Access Compliance Report

Public Rights-of-Way

Intersection ID: N/A	Main Street: E_STONEWALL_ST	Cross Street: S_BREVARD_ST	Location: S
ADA ID: 9F21A1378112	Ramp Type: Perp	Initial Pass/Fail: Fail	Overall Compliance: No
		Severity Score: 12.5

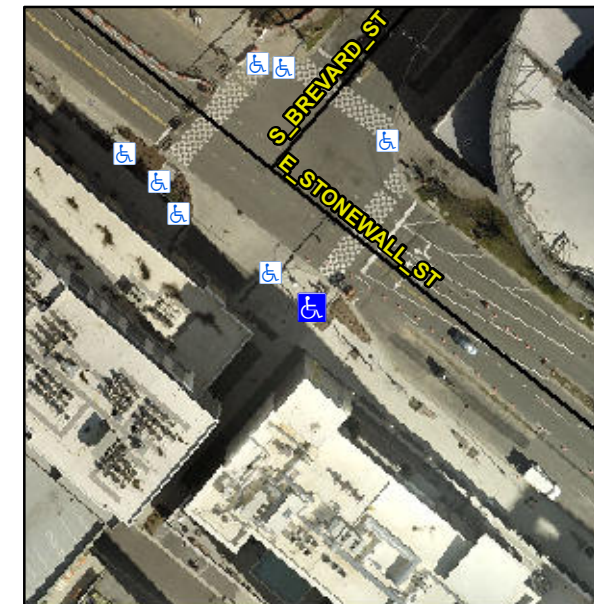
Not Found, R304.2.2

Compliance	Description	Data	Compliance	Description	Data
N/A	Ramp Length (in)	83.0	No	Ramp Slope (%)	9.8
Yes	Ramp Width (in)	95.0	Yes	Ramp XSlope (%)	0.7
N/A	Flare Type LT	N/A	N/A	Flare Type RT	N/A
N/A	Flare Slope LT (%)	N/A	N/A	Flare Slope RT (%)	N/A
N/A	Flare Traversable LT?	No	N/A	Flare Traversable RT?	No
N/A	Landing Length (in)	N/A	N/A	DWS Provided?	N/A
N/A	Landing Width (in)	N/A	N/A	DWS Contrast?	N/A
N/A	Landing Slope (%)	N/A	N/A	DWS Length (in)	N/A
N/A	Landing X Slope (%)	N/A	N/A	DWS Full Width?	N/A
N/A	Landing Curb? (Y/N)	N/A	N/A	DWS Offset (in)	N/A
N/A	Shared Landing?	N/A			
N/A	Gutter Ponding?	N/A	N/A	Gutter Slope (%)	N/A
N/A	Gutter Lip Ht (in)	N/A	N/A	Gutter X Slope (%)	N/A
N/A	Painted X Walk1?	Yes	N/A	Painted X Walk2?	N/A
	X Walk 1 Direction	To NE		X Walk 2 Direction	N/A
N/A	X Walk 1 Width (in)	144.0	N/A	X Walk 2 Width (in)	N/A
	X Walk 1 Slope (%)	2.7		X Walk 2 Slope (%)	N/A
	X Walk 1 X Slope (%)	0.9		X Walk 2 X Slope (%)	N/A

Remove & Replace Entire Ramp.
